CASE # DCI2021-00026

CASE NAME: HOMES AT 81 WEST RPD

REMAND

**SUBJECT: Supplemental Staff Report Memorandum
DCI2021-00026, Homes at 81 West RPD**

S1: Revised Master Concept Plan dated April 6, 2023

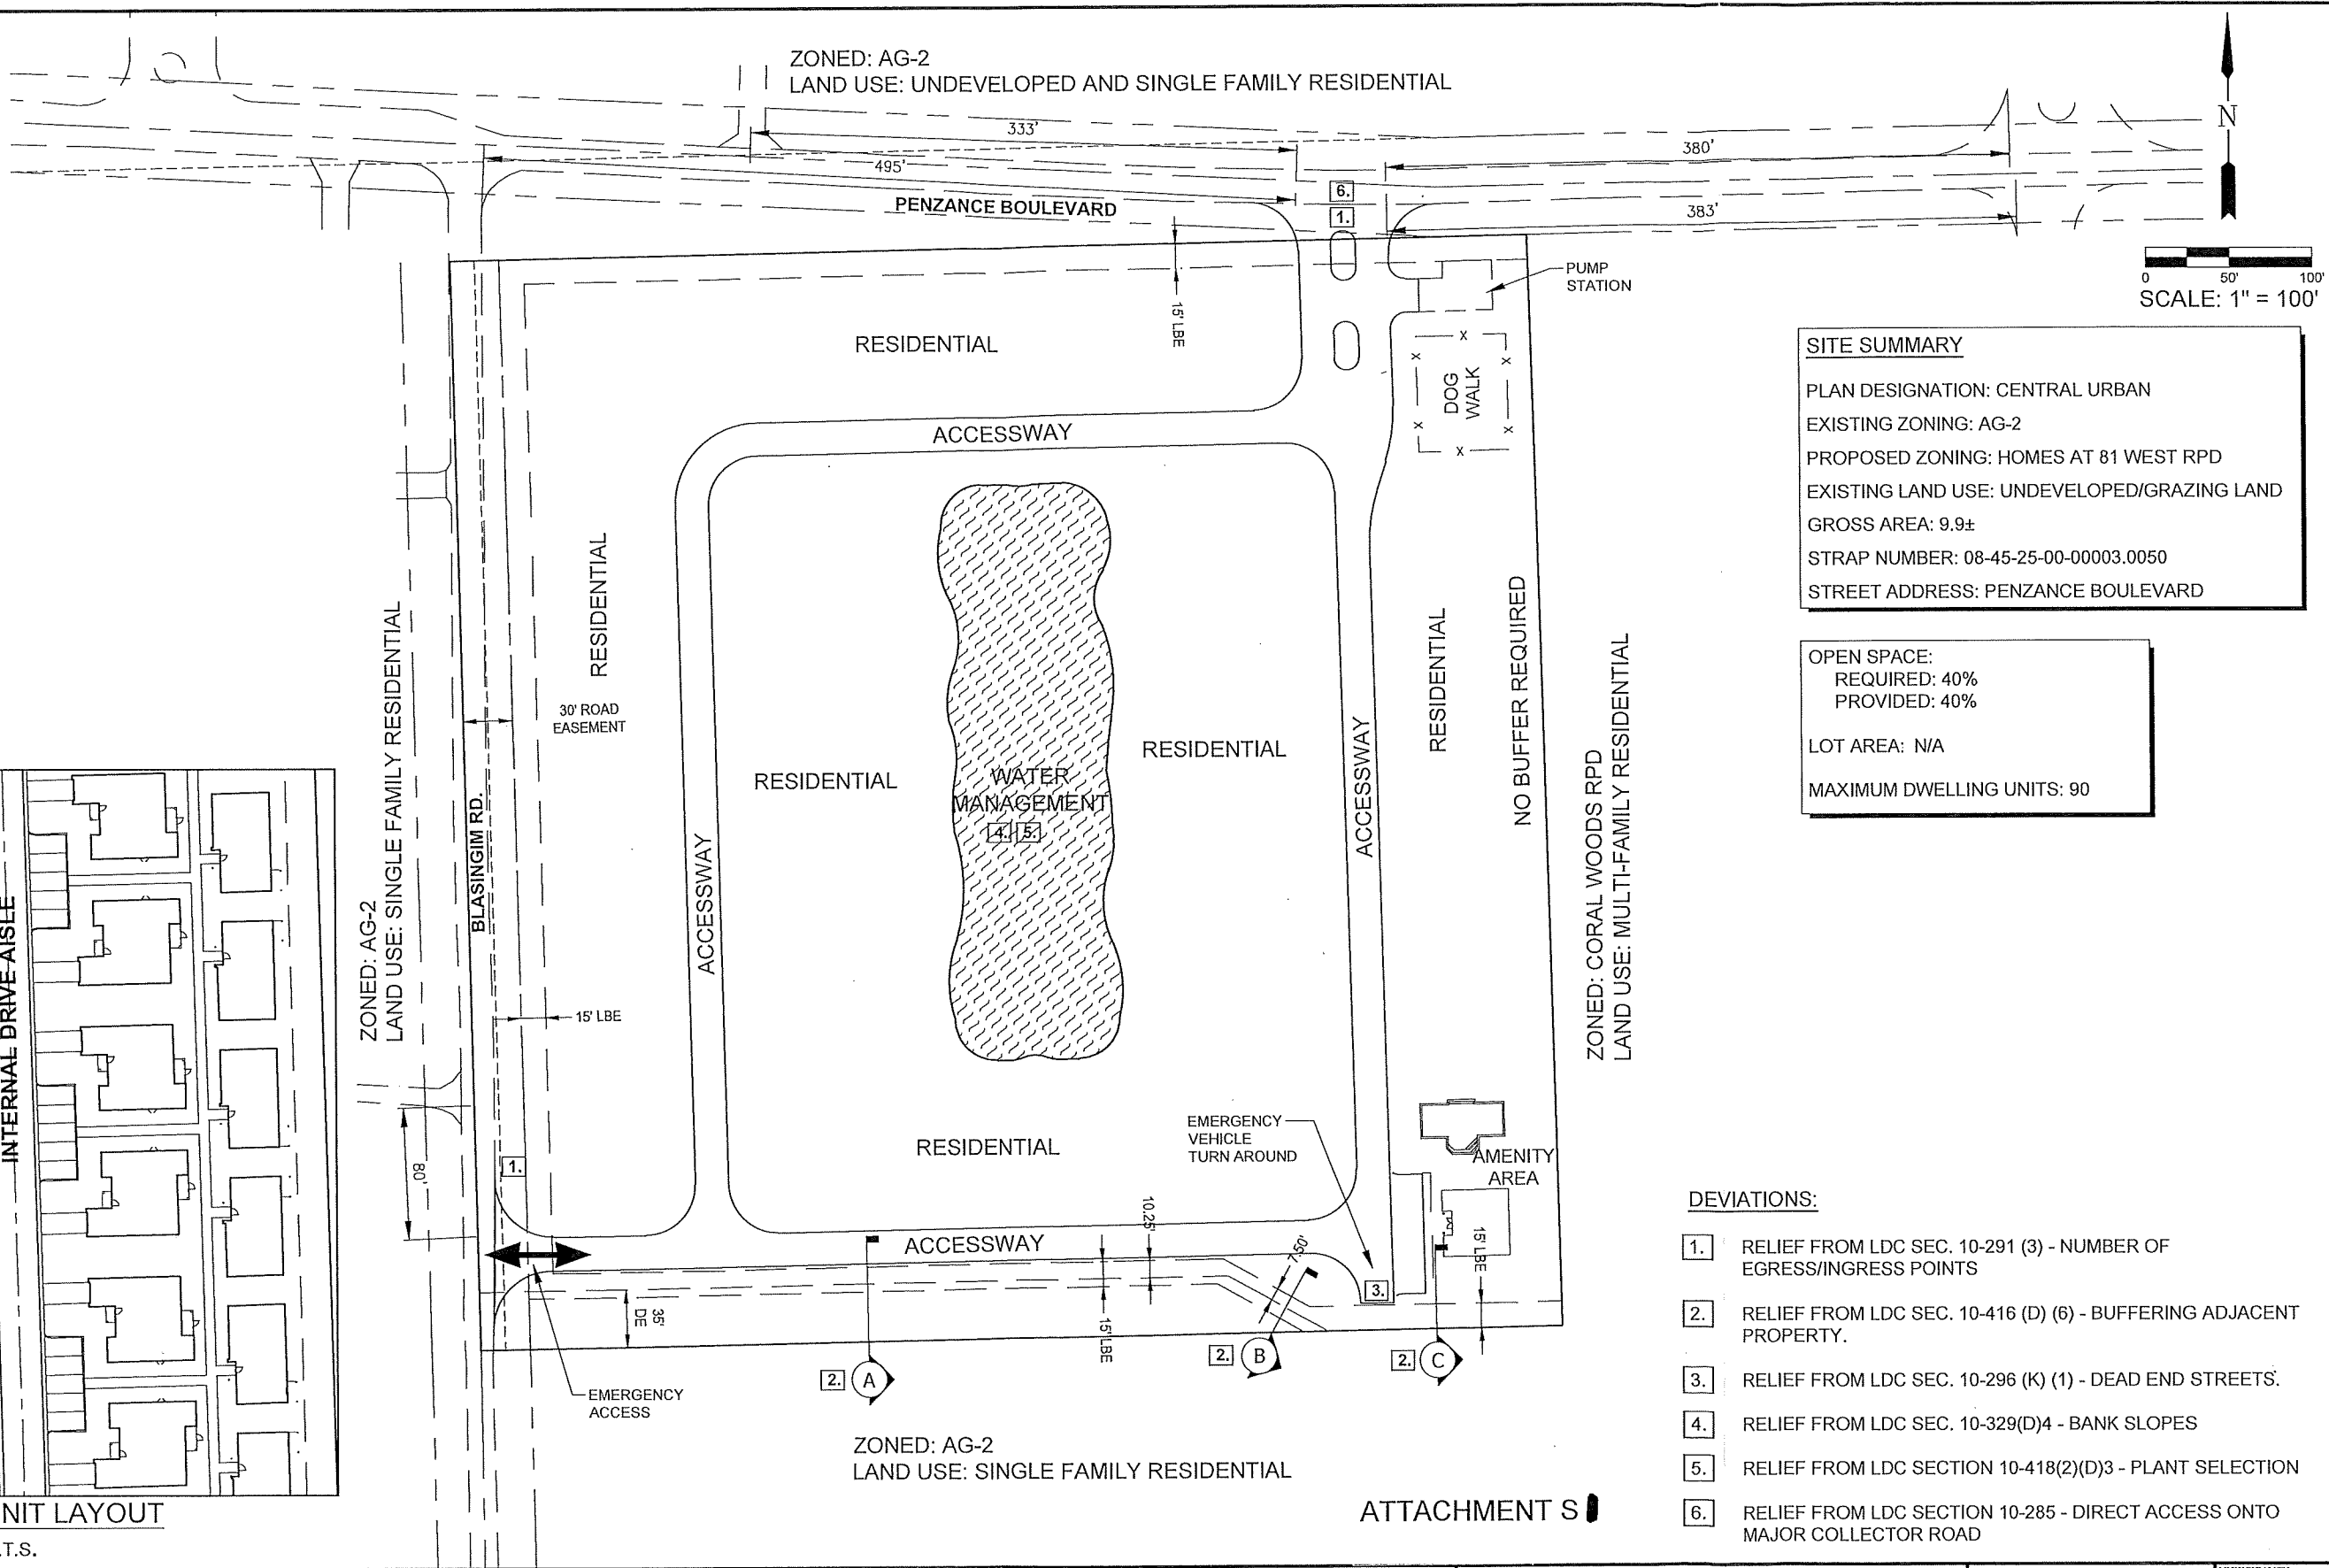
The applicant, in response to the Board's remand and subsequent coordination with DOT, submitted a revised master concept plan and schedule of deviations to address the relief required to relocate the project's access as directed by the Board (see Attachments S1 and S2, respectively). The applicant's justification for the requested deviation notes that Penzance Boulevard is the only feasible access alternative to accommodate the Board's request and that the functional classification of Penzance Boulevard was changed from minor collector to major collector after the subject application was filed. Finally, the applicant's justification notes that the project's access on Penzance Boulevard, as shown on the revised master concept plan, meets the connection separation standards established in LDC Section 10-285.

The justification set forth by the applicant, in the context of the Board's remand, meets the criteria for approval of the requested deviation. The requested deviation will enhance the achievement of the objectives of the planned development by placing the project's principal access point in a location that provides adequate access to the County's roadway network. The requested deviation, as proposed, will also serve to protect public health, safety, and welfare. The revised access location meets the connection separation standards established in LDC Section 10-285 and limits the access on to Blasingim Road, which is currently a privately-maintained local road, to "emergency only;" therefore, staff recommends **APPROVAL** of the requested deviation.

- *The project must construct one (1) access onto Blasingim Road in accordance with the requirements of LDC Section 10-296. The Blasingim Road access will be restricted to emergency use only and will remain as such until Blasingim Road is interconnected with the planned extension of Crystal Drive to Plantation Road. The emergency use access must be converted to a standard access to Blasingim Road upon the completion of the extension of Crystal Drive to Plantation Road. This condition does not prevent the construction of a residents/guests only access gate in compliance with LDC Section 34-1748 upon the termination of the emergency use only status.*

PROPOSED DEVIATION LOCATIONS

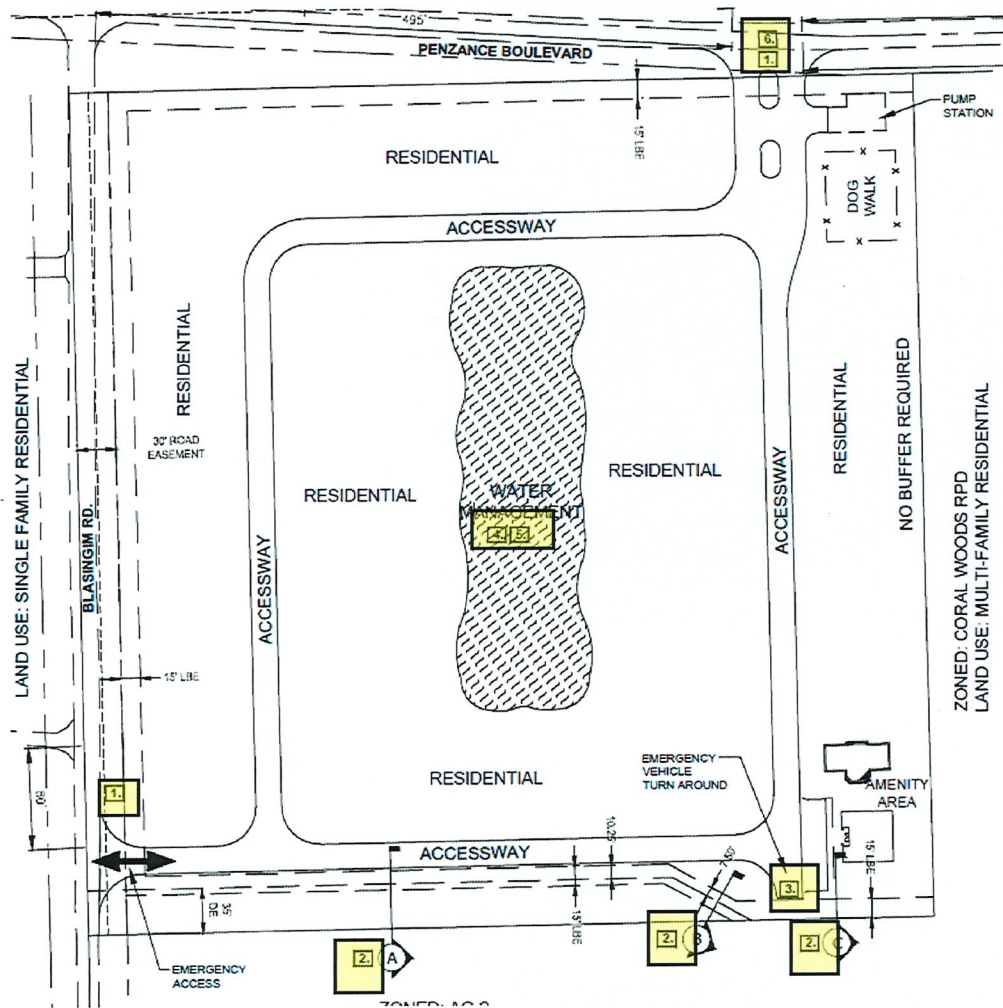
1. Deviation 1 seeks relief from LDC Sec. 10-291(3) which requires residential projects of 5 acres or greater to provide more than one means of ingress or egress to instead allow a full access to Penzance Boulevard and an emergency ingress/egress to Blasingim Road, which may be converted in the future into a full access subject to a Blasingim Road/Crystal Drive interconnection.

2. Deviation 2 seeks relief from LDC Sec. 10-416 (d) (6), which states If roads, drives, or parking areas associated with residential subdivisions or with a multi-family or non-residential use are located less than 125 feet from an existing single-family residential subdivision or single-family residential lots, a solid wall or combination berm and solid wall not less than eight feet in height must be constructed not less than 25 feet from the abutting property and landscaped (between the wall and the abutting property) with a minimum of five trees and 18 shrubs per 100 lineal feet or a 30-foot wide Type F buffer with the hedge planted a minimum of 20 feet from the abutting property. Where residences will be constructed between the road, drive or parking area and the existing residential subdivision or lots, the wall or wall and berm combination are not required.

3. Deviation 3 seeks relief from LDC Sec. 10-296(k) (1), which states dead-end streets, designed to be so permanently, must be closed at one end by a circular turn around for vehicles and constructed in compliance with the LDC.

6. Deviation 6 seeks relief from LDC Sec. 10-285, Connection Separation, which indicates that all lots in urban areas with access alternatives will not be permitted direct motor vehicle access to an arterial or major collector, to instead allow the Homes at 81 West RPD to provide primary project access to Penzance Boulevard, which has been classified as a major collector roadway on the County's functional classification map.

The project must construct one (1) access onto Blasingim Road in accordance with the requirements of LDC Section 10-296. The Blasingim Road access will be restricted to emergency use only and will remain as such until Blasingim Road is interconnected with the planned extension of Crystal Drive. The emergency use access must be converted to a standard access to Blasingim Road upon the completion of the extension of Crystal Drive to Blasingim Road. This condition does not prevent the construction of a residents/guests only access gate in compliance with LDC Section 34-1748 upon the termination of the emergency use only status.
